KIRKSVILLE REGIONAL AIRPORT KIRKSVILLE, MISSOURI MODOT PROJECT NO. 24-028A-1

ADDENDUM NO. 3 TO

CONTRACT DOCUMENTS, SPECIFICATIONS AND PLANS FOR IMPROVEMENTS TO THE KIRKSVILLE REGIONAL AIRPORT KIRKSVILLE, MISSOURI MODOT PROJECT NO. 24-028A-1

C.L.G. CHECKED BY: SHEET NAME: SITE DRAINAGE PLAN AND PROFILE -

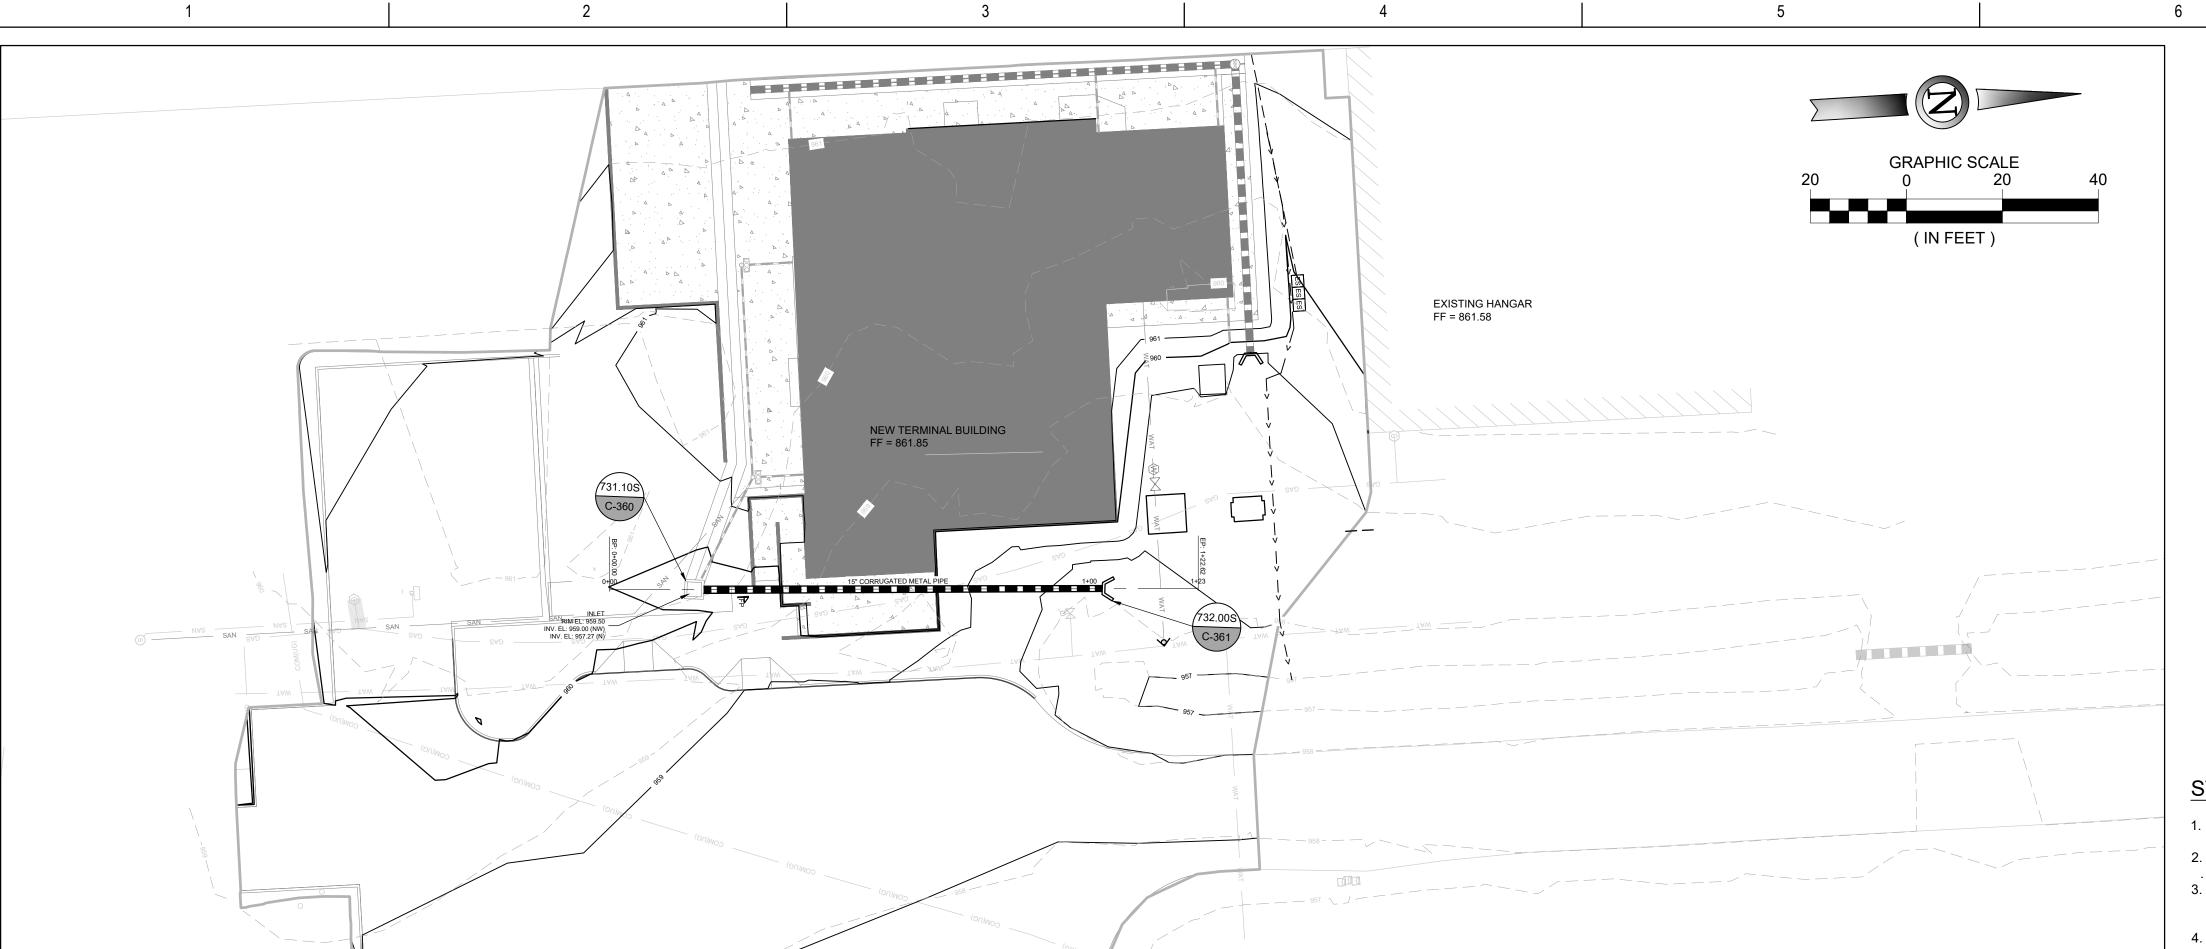
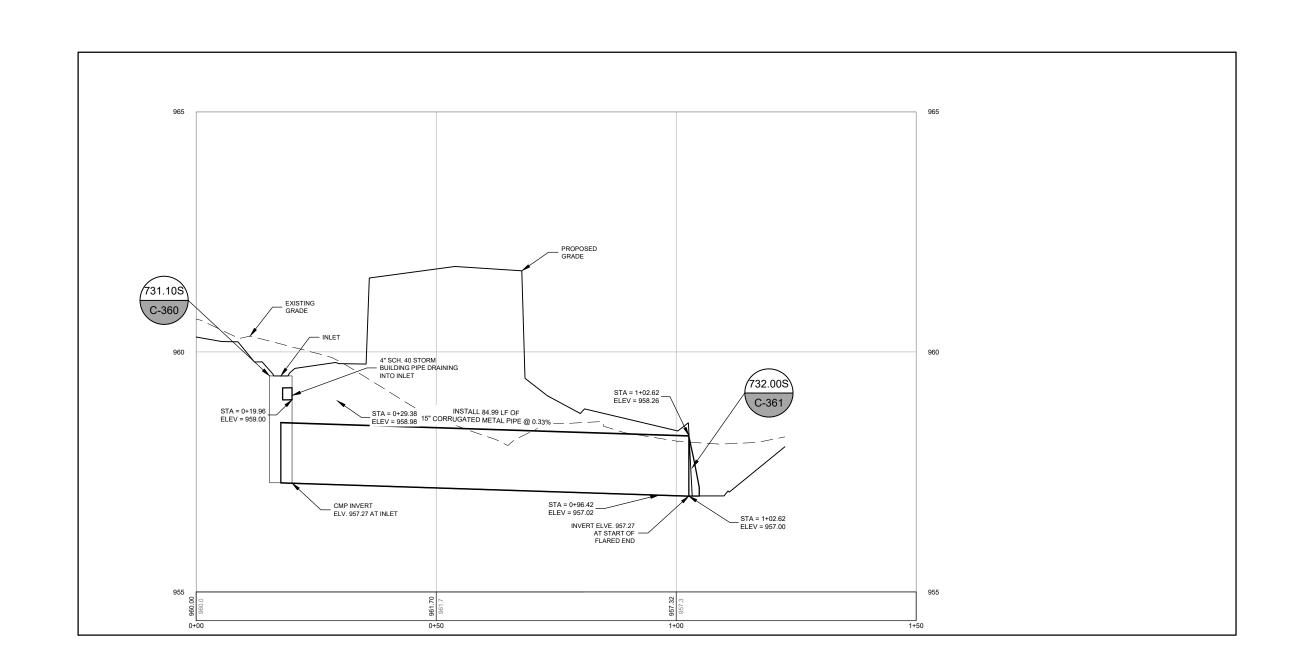
Revision: Roof drain connect to storm sewer system added.

SHEET NAME:
DRAINAGE DETAILS

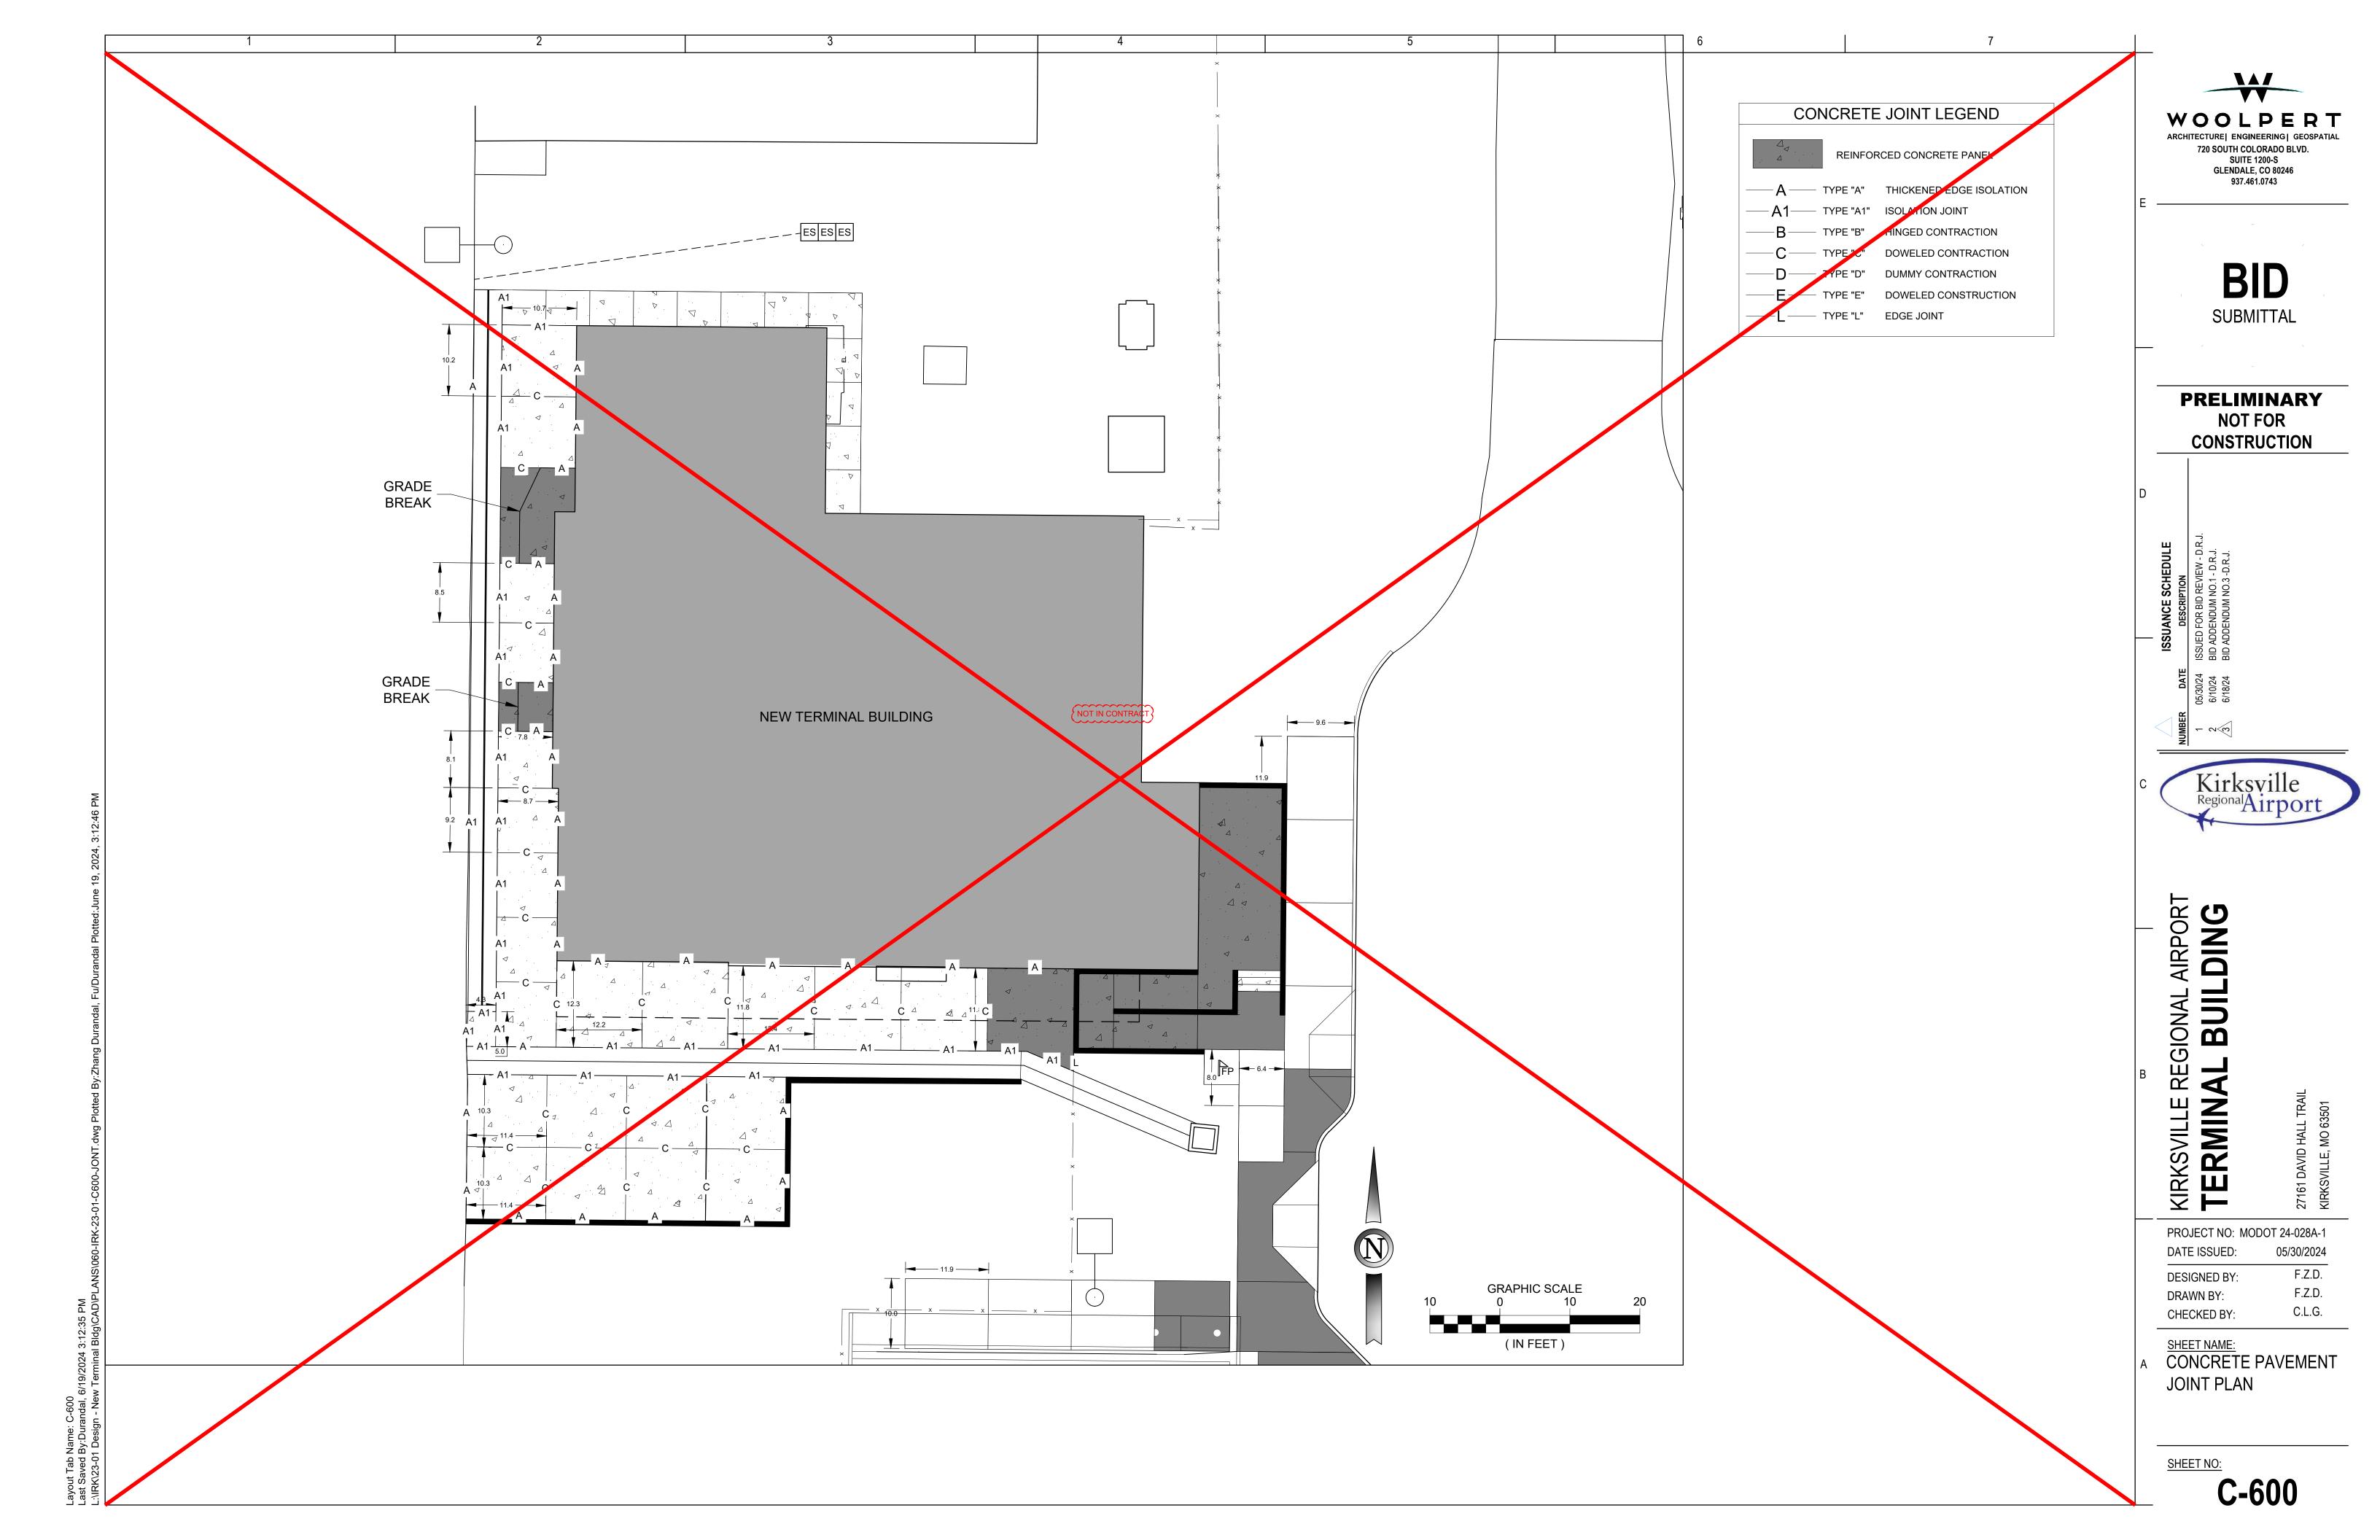
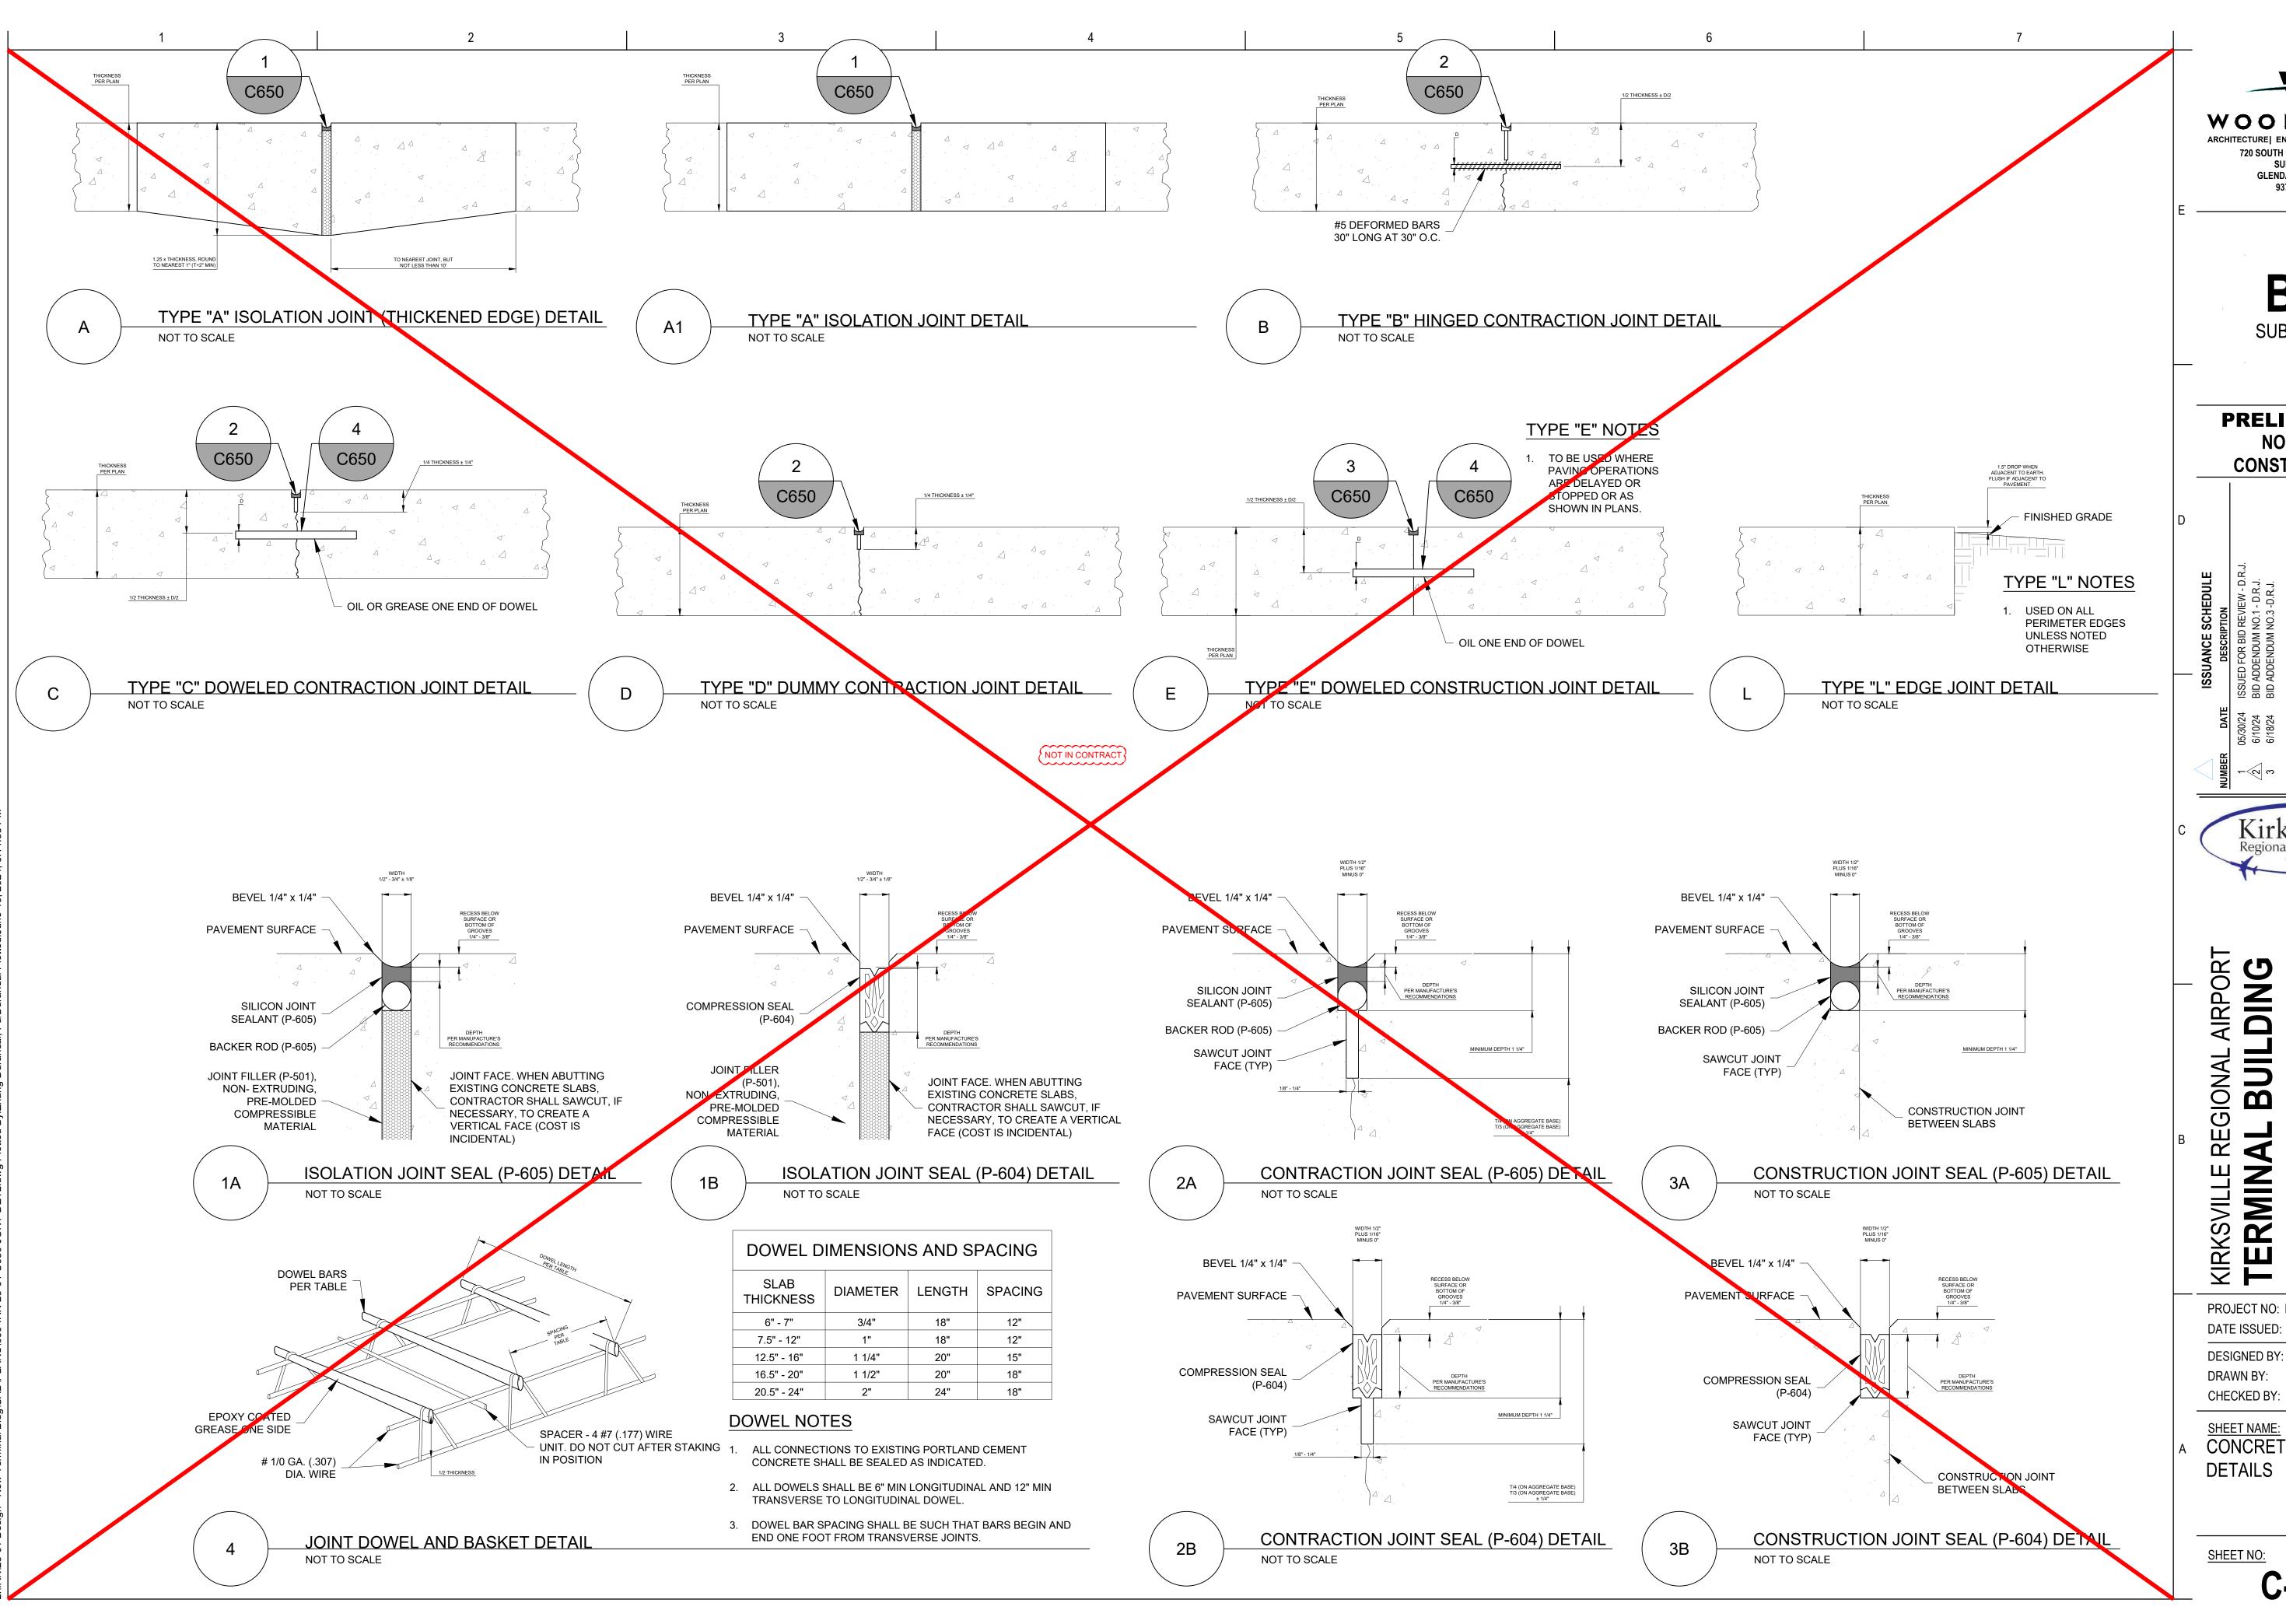
Revision: Added information and graphics the Vertical Cleanout Riser Detail.
